1 REPLACED PER ADDENDUM No. 1 DATED MAY 06, 2014

ROUTES 15,40,58,95,127 & 247 BRIDGES
GENERAL PLAN NO. 2

UNIT: 3489
PROJECT NUMBER & PHASE: 0812000315 1 CONTRACT NO.: 08-1C4101

ROUTES 15,40,58,95,127 & 247 BRIDGES
GENERAL PLAN NO. 7

Br No. 54-0758L/R, Rte 40, PM R54.75
No Scale

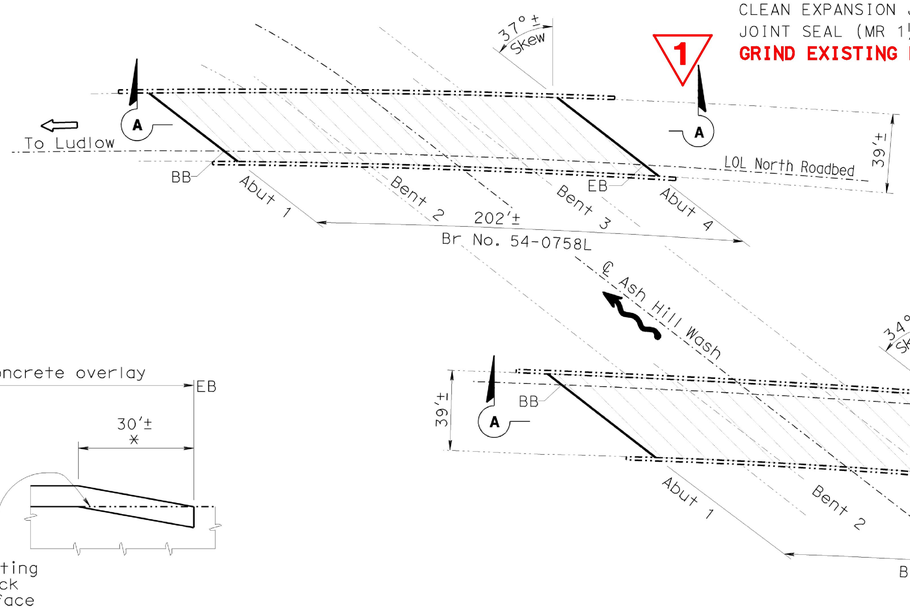
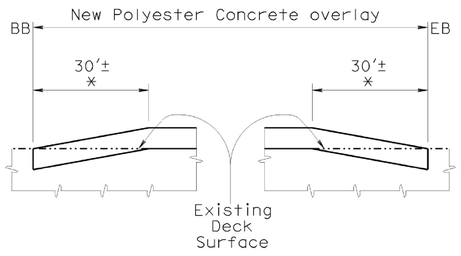
RAPID SETTING CONCRETE (PATCH)	20 CF
~~REMOVE CONCRETE DECK SURFACE~~	~~2,340 SQFT~~
REMOVE UNSOUND CONCRETE	20 CF
PREPARE CONCRETE BRIDGE DECK SURFACE	7,878 SQFT
FURNISH POLYESTER CONCRETE OVERLAY	591 CF
PLACE POLYESTER CONCRETE OVERLAY	7,878 SQFT
CLEAN EXPANSION JOINT	98 LF
JOINT SEAL (MR 1½")	98 LF
GRIND EXISTING BRIDGE DECK	**260 SQYD**

* Limits of ~~remove concrete deck surfacing~~ grind existing bridge deck 0 inch min to ¾ inch maximum full width. Grind flush to conform with existing profile.

RAPID SETTING CONCRETE (PATCH)	19 CF
~~REMOVE CONCRETE DECK SURFACE~~	~~2,340 SQFT~~
REMOVE UNSOUND CONCRETE	19 CF
PREPARE CONCRETE BRIDGE DECK SURFACE	7,488 SQFT
FURNISH POLYESTER CONCRETE OVERLAY	562 CF
PLACE POLYESTER CONCRETE OVERLAY	7,488 SQFT
CLEAN EXPANSION JOINT	98 LF
JOINT SEAL (MR 1½")	98 LF
GRIND EXISTING BRIDGE DECK	**260 SQYD**

Br No. 54-0872L/R, Rte 40, PM R134
No Scale

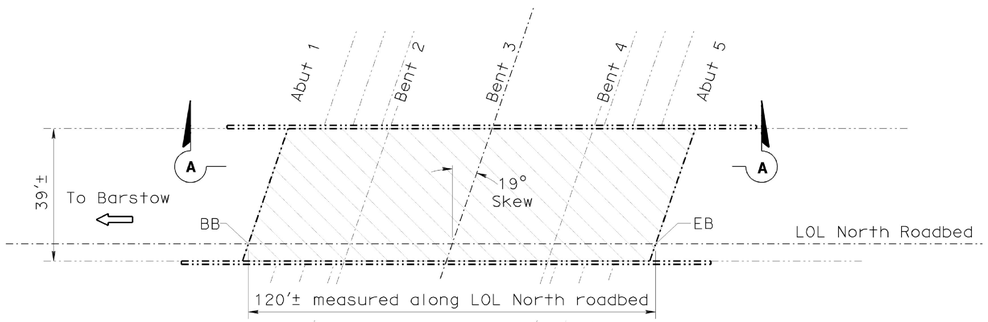
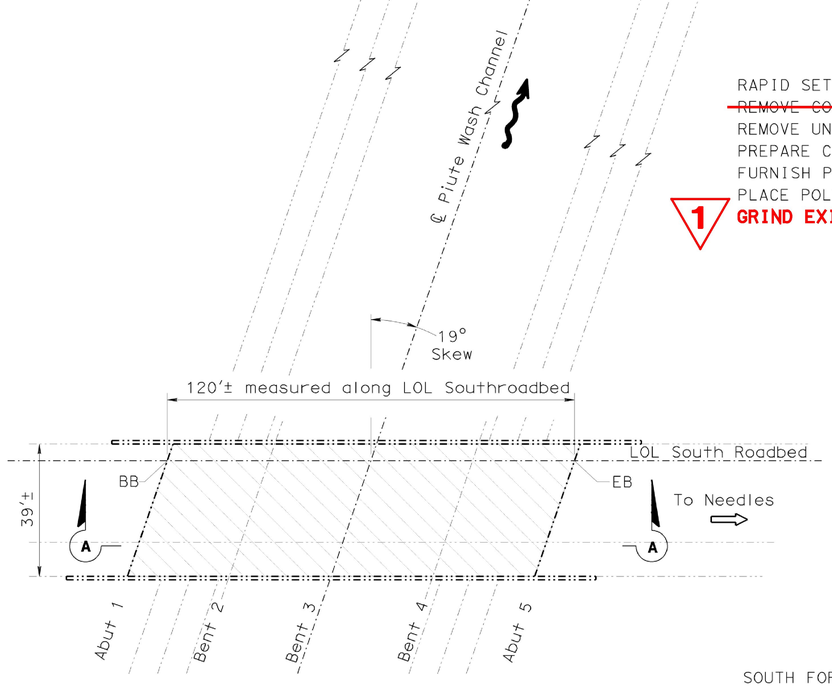
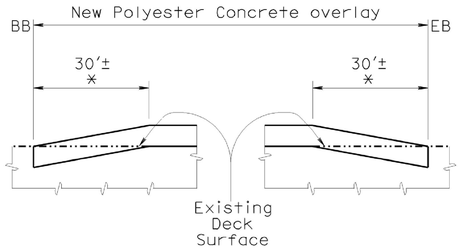
RAPID SETTING CONCRETE (PATCH)	12 CF
~~REMOVE CONCRETE DECK SURFACE~~	~~2,340 SQFT~~
REMOVE UNSOUND CONCRETE	12 CF
PREPARE CONCRETE BRIDGE DECK SURFACE	4,680 SQFT
FURNISH POLYESTER CONCRETE OVERLAY	351 CF
PLACE POLYESTER CONCRETE OVERLAY	4,680 SQFT
1 **GRIND EXISTING BRIDGE DECK**	**260 SQYD**

RAPID SETTING CONCRETE (PATCH)	12 CF
~~REMOVE CONCRETE DECK SURFACE~~	~~2,340 SQFT~~
REMOVE UNSOUND CONCRETE	12 CF
PREPARE CONCRETE BRIDGE DECK SURFACE	4,680 SQFT
FURNISH POLYESTER CONCRETE OVERLAY	351 CF
PLACE POLYESTER CONCRETE OVERLAY	4,680 SQFT
1 **GRIND EXISTING BRIDGE DECK**	**260 SQYD**

1 grind existing bridge deck

* Limits of ~~remove concrete deck surfacing~~ 0 inch min to ¾ inch maximum full width. Grind flush to conform with existing profile.

1 **REPLACED PER ADDENDUM No. 1 DATED MAY 06, 2014**
